MEMORANDUM

To: Planning Board
From: Juliet T.H. Walker, Planning Director *JTW*
Jillian Harris, Planner 1
Subject: Staff Recommendations for the October 15, 2020 Planning Board Meeting
Date: 10/09/2020

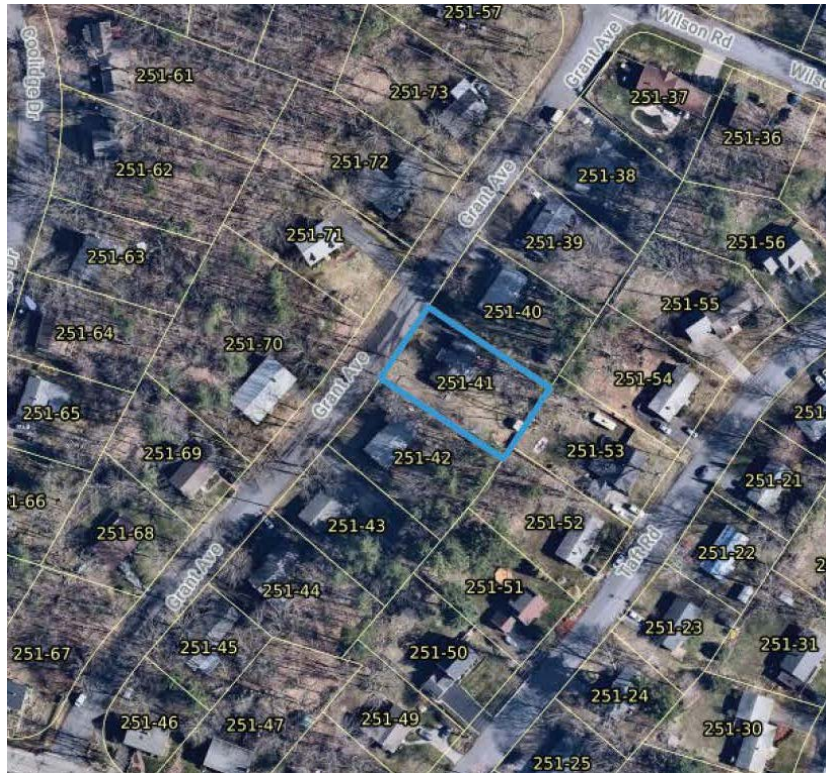
The attached enclosure designs (dated January 16, 2020 from Bernie Pelech) were included in the presentation as a handout from the applicant and discussed as part of the approval. The applicant is seeking an amended approval to construct a chain link enclosure due to cost and has included a spec sheet identifying the proposed materials and construction they wish to proceed with.

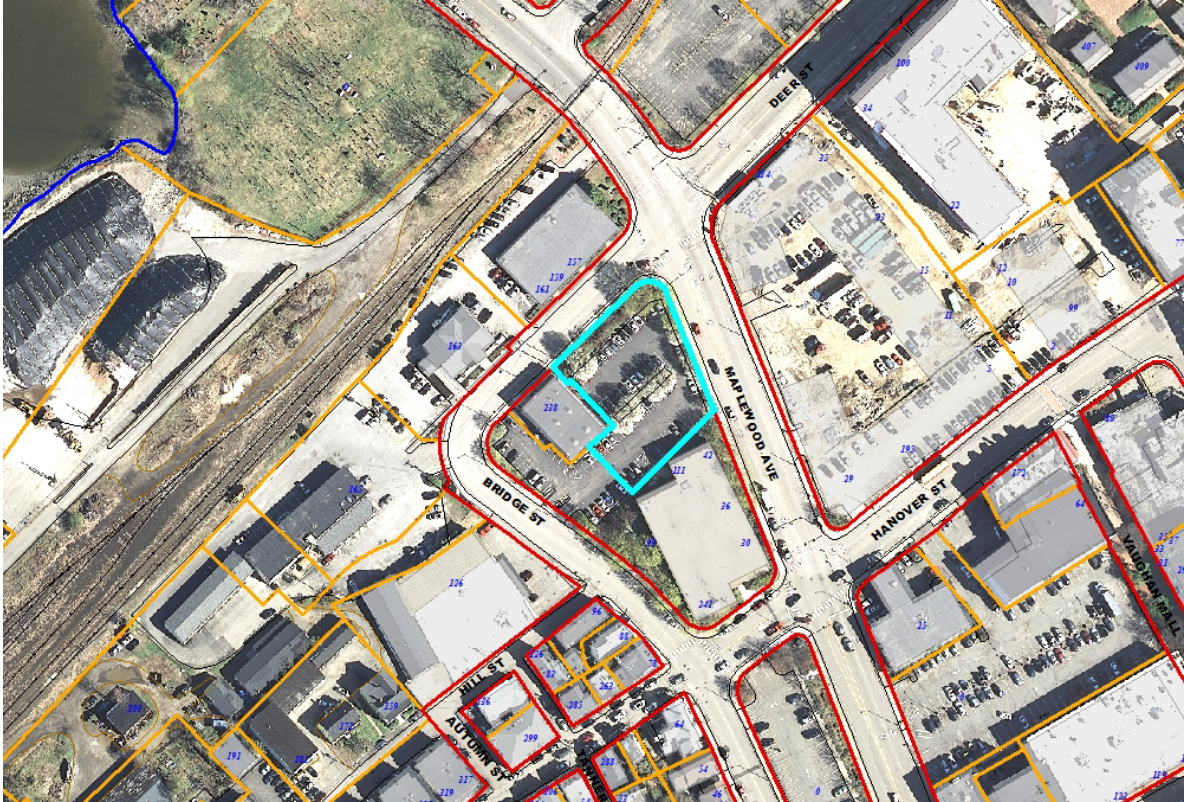
2.5) Bike rack in parking garage is not accessible when vehicles are parked in abutting spaces. Plans shall be adjusted to show that the rack has been moved to a more visible and accessible location.
